DEVELOPMENT REVIEW BOARD
SUPPLEMENTAL SUBMITTAL

PROJECT NO. PR-2021-005411

Application No. SI-2021-00760

**RE: AUTONATION DRB RESPONSE TO COMMENTS
PR-2021-005411**

SITE PLAN FOR
BUILDING PERMIT

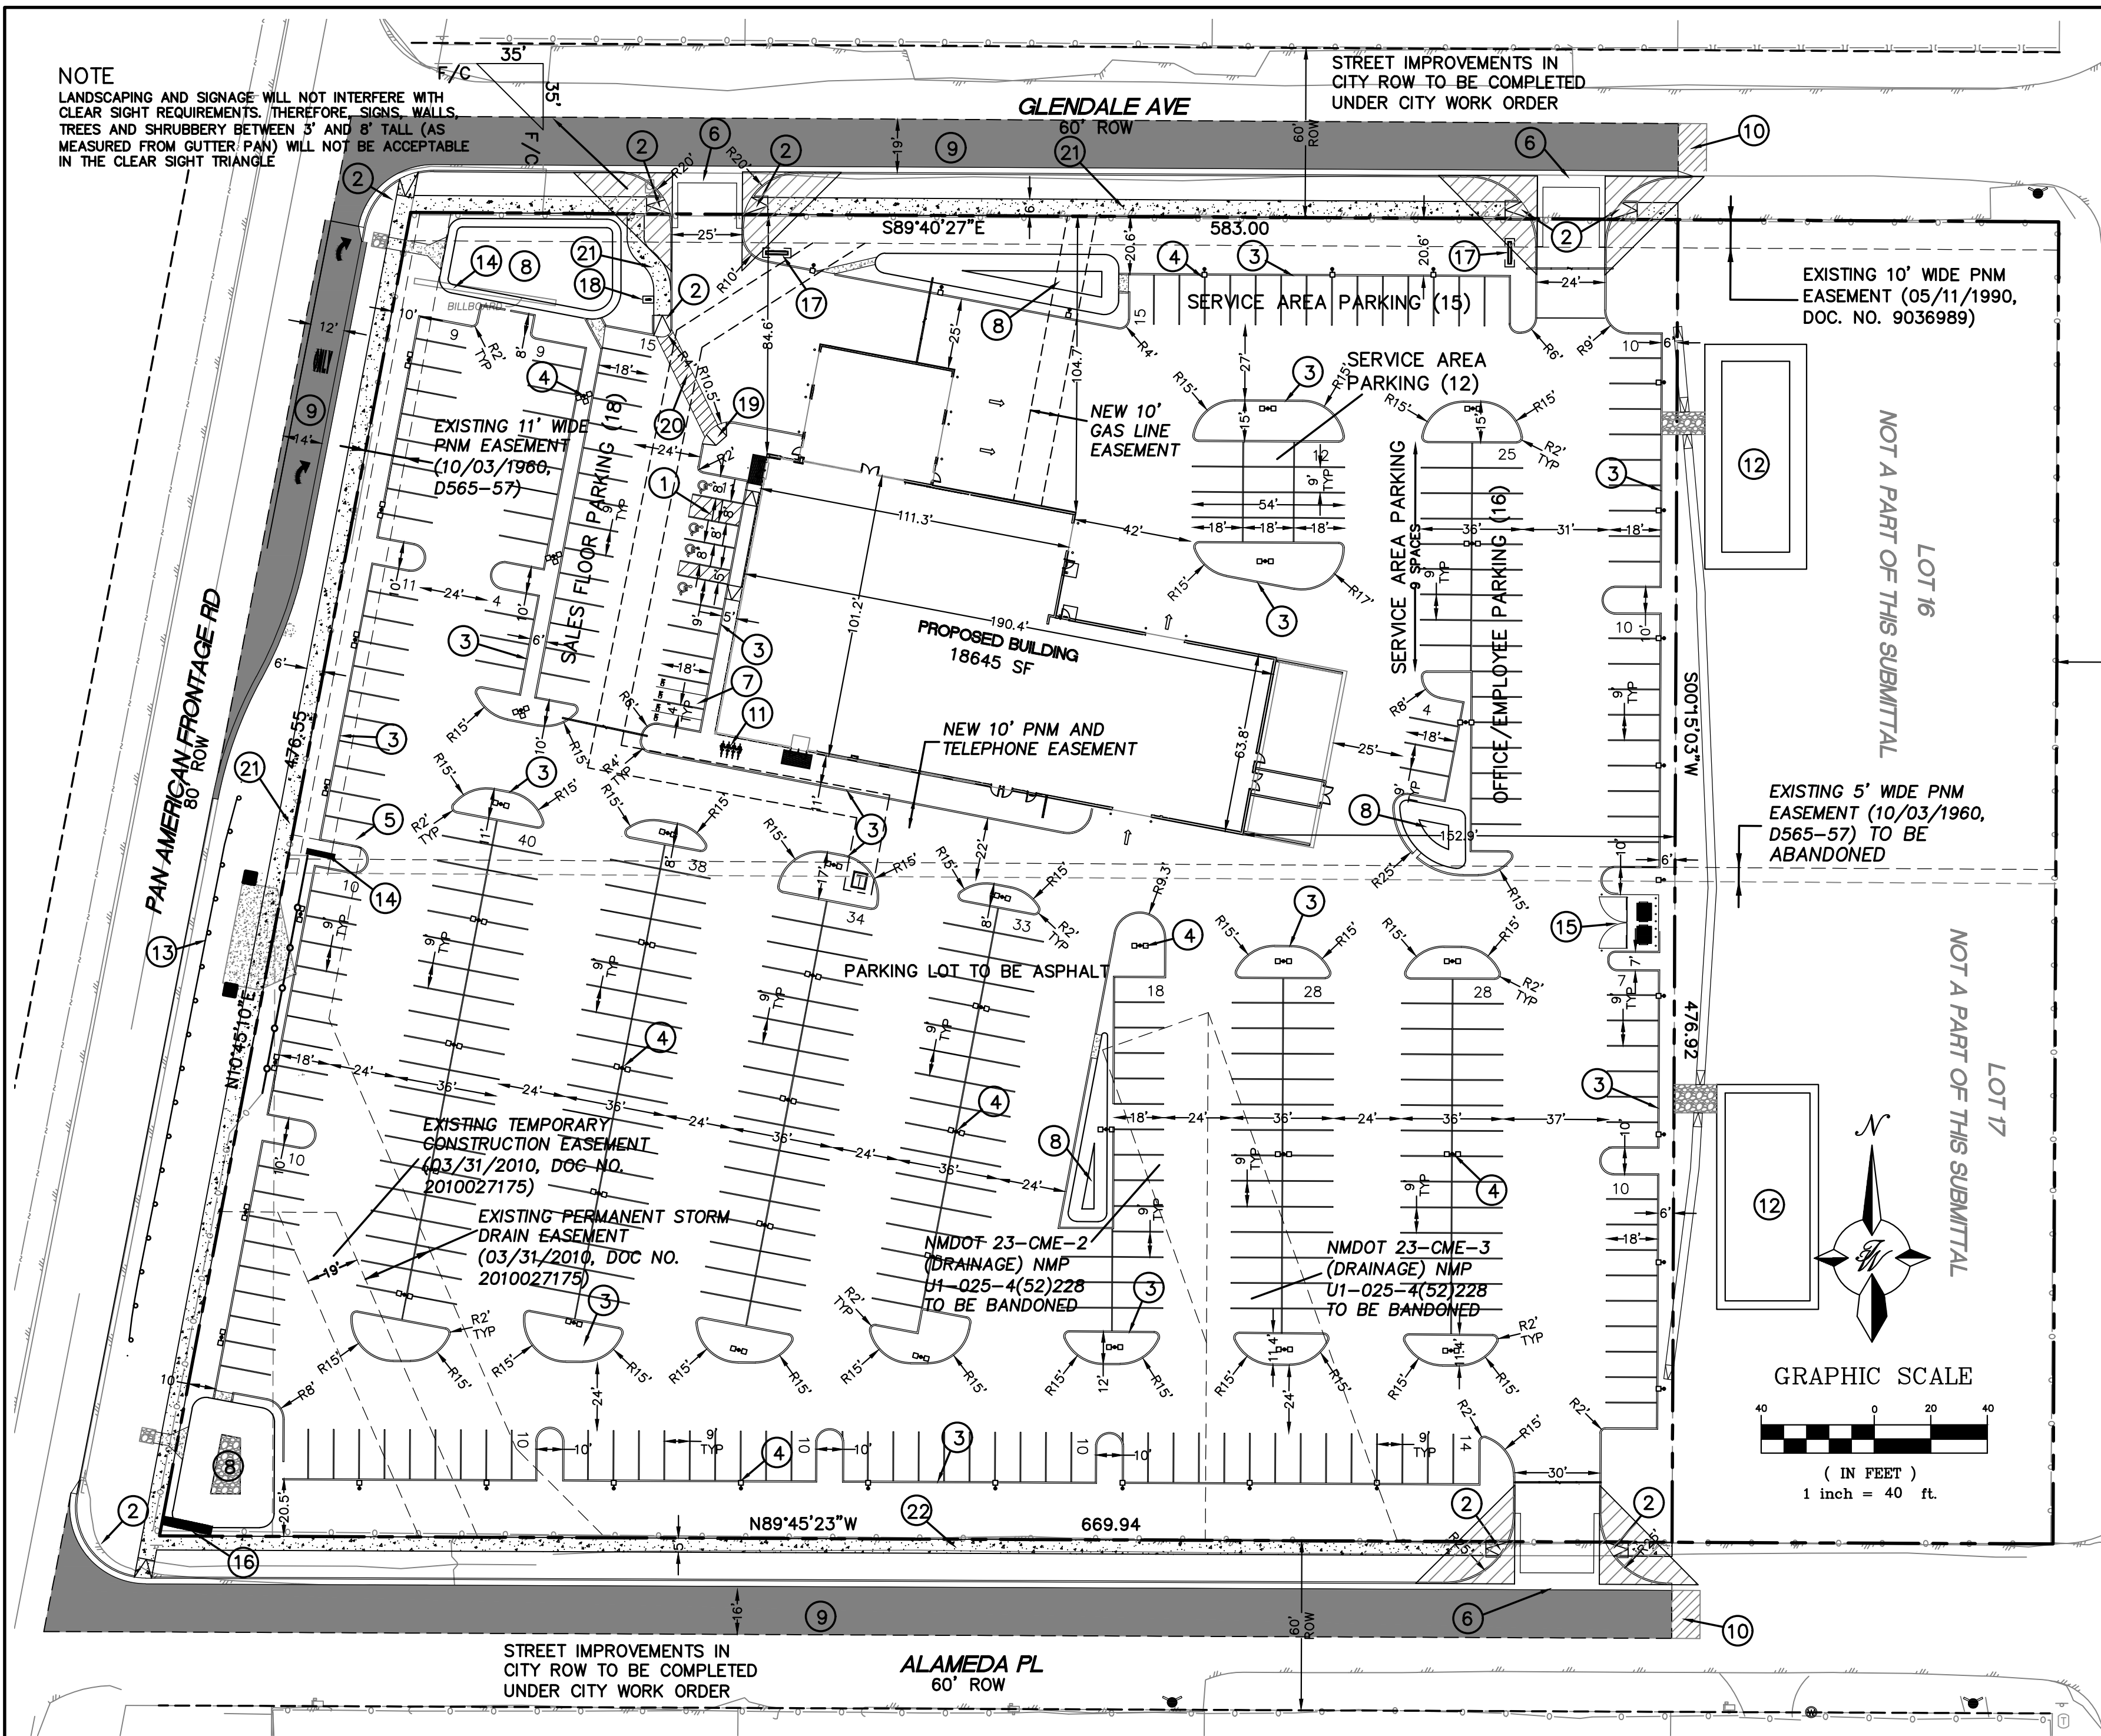
5. Provide bold note for work order being required for all public infrastructure. Eliminate the note about 24-hour required construction for arterial roads on the site plan.
The 24-hour work note was deleted and the other note was added stating a Work Order is required for any work in the City right-of-way.

6. Show overall required parking in the parking calculations versus provided parking. The hatching is difficult to read for storage of vehicles versus customer and employee parking. Use notes on the site plan as well as signage for designated parking.
A column was added to the parking calculation table showing what is required. Also, the hatching was removed and notes added designating the different parking areas on the Site Plan.

7. Label parking aisle width south of the building.
The width is now dimensioned.
8. Label width of all handicapped spaces, and accessible aisles on the site plan.

9. Call out all handicapped signage and motorcycle parking signage on the site plan with a keyed note.

15. Turning radii for parking lot islands shall match DPM standards. Provide 15-foot turning radii for all of the landscape islands at the end of the aisles.

17. Call out asphalt paved surface on the site plan for internal parking lot paving.

All of the turning radii was updated to the 15-foot radius.

A note was added to the Site Plan stating the parking lot will be asphalt.

Landscape Plan

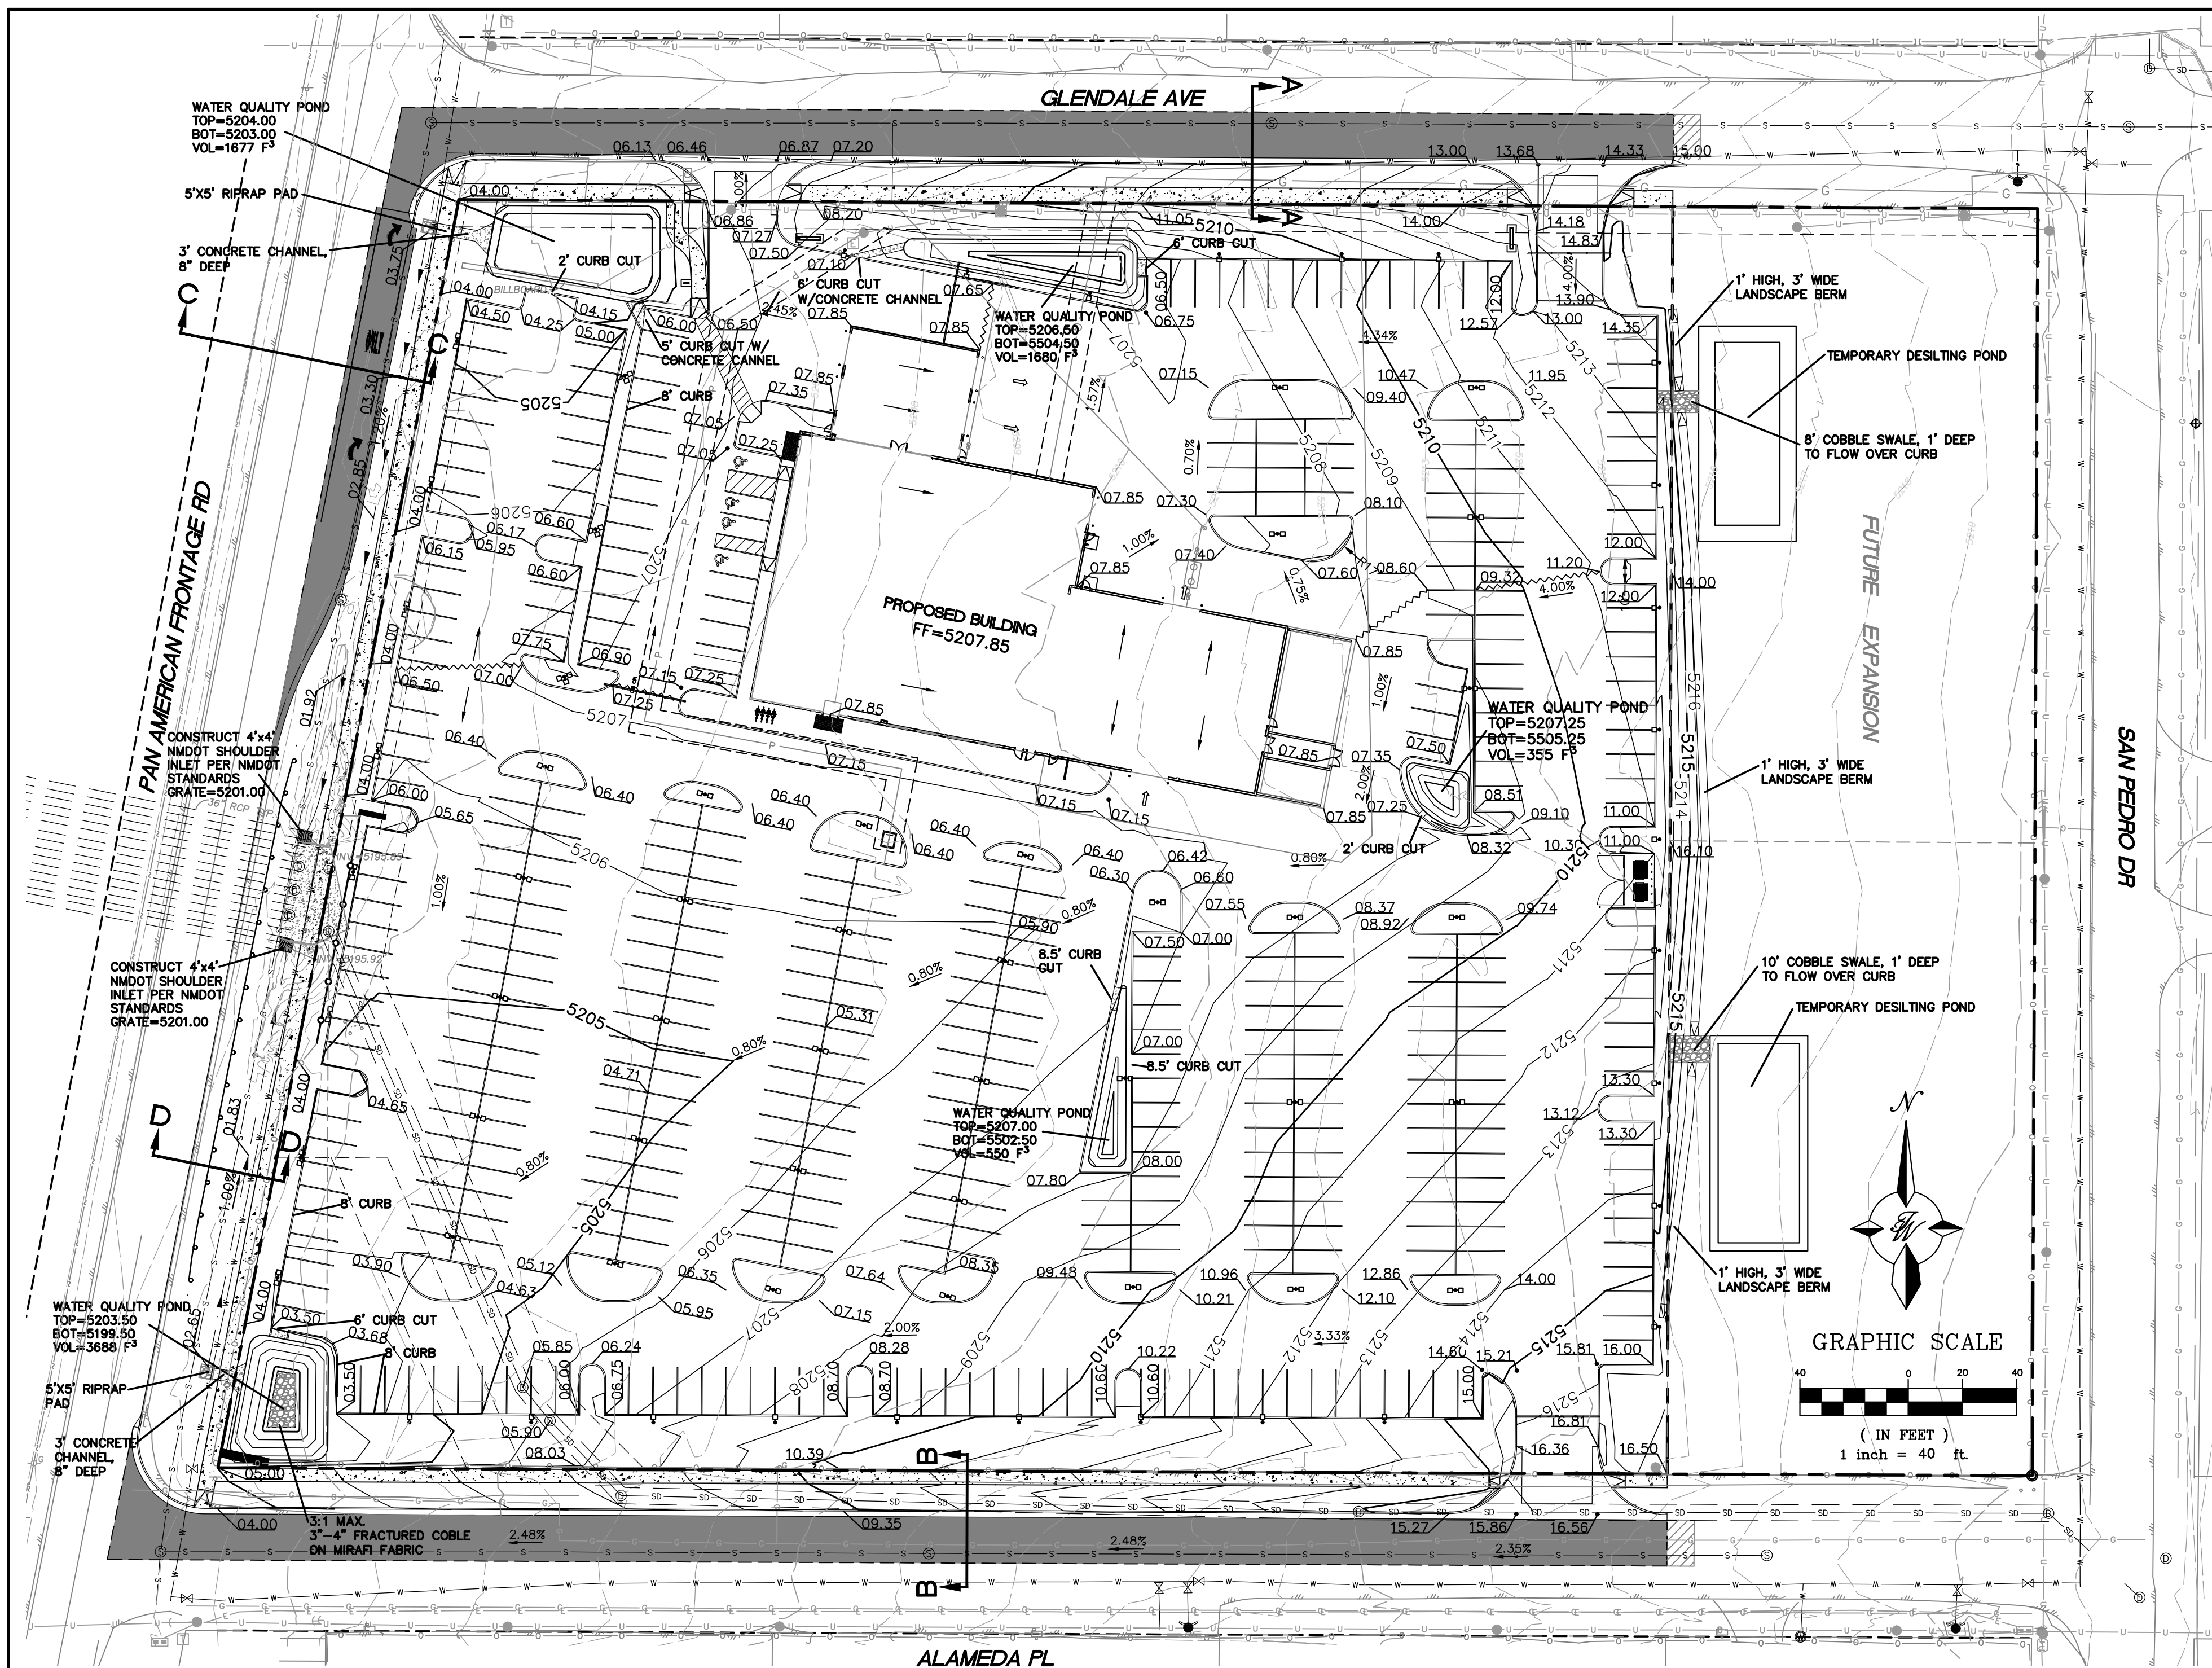
11. Show clear sight triangles on the landscaping plan, and include the standard note. Clear sight triangle should also be shown on the southern driveway.

Clear Sight Triangles were added to the Landscape Plan and the Alameda entrance on the Site Plan.

ANU-P-84

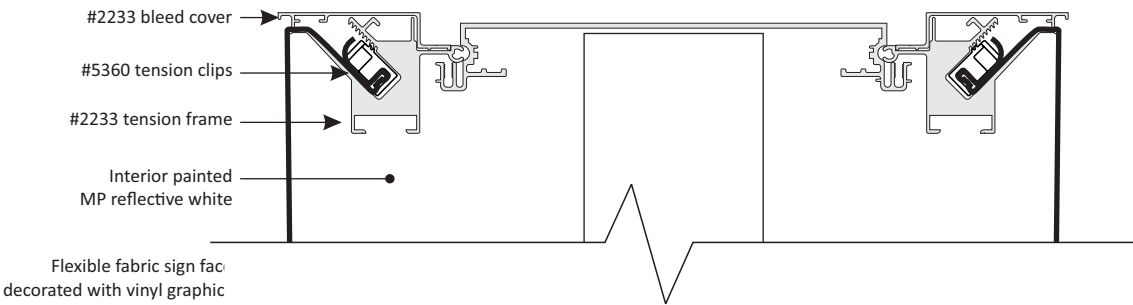
8. Signage is limited to 26 in height, see table 5-12-2.
The pole sign was revised to only be 26 feet tall.
9. Has the site been graded? If the site is vacant and ungraded, a Sensitive Lands Analysis per 5-2(C)(1) of the IDO must be performed with an analysis of site constraints related to sensitive lands. New subdivisions of land and site design shall avoid locating development, except for open spaces and areas that will not be disturbed during the development process, in the following types of sensitive lands:

1. Per footnote 3. Please provide elevation of highway and elevation of lot to determine allowed sign height.
The highway is approximately the same elevation as the lot at the location of the pole sign therefore the sign was lowered to a maximum height of 26 feet.
2. If sign exceeds allowed height a variance will be required.
No variance is requested, the sign is now 26 feet high.
3. Show location of freestanding sign on site plan
The freestanding (pole) sign is located at the southwest corner of the property and is called out with a keyed note.
4. Sign height allowed in NR-LM is 26'
The sign detail was updated to show a height of 26'.
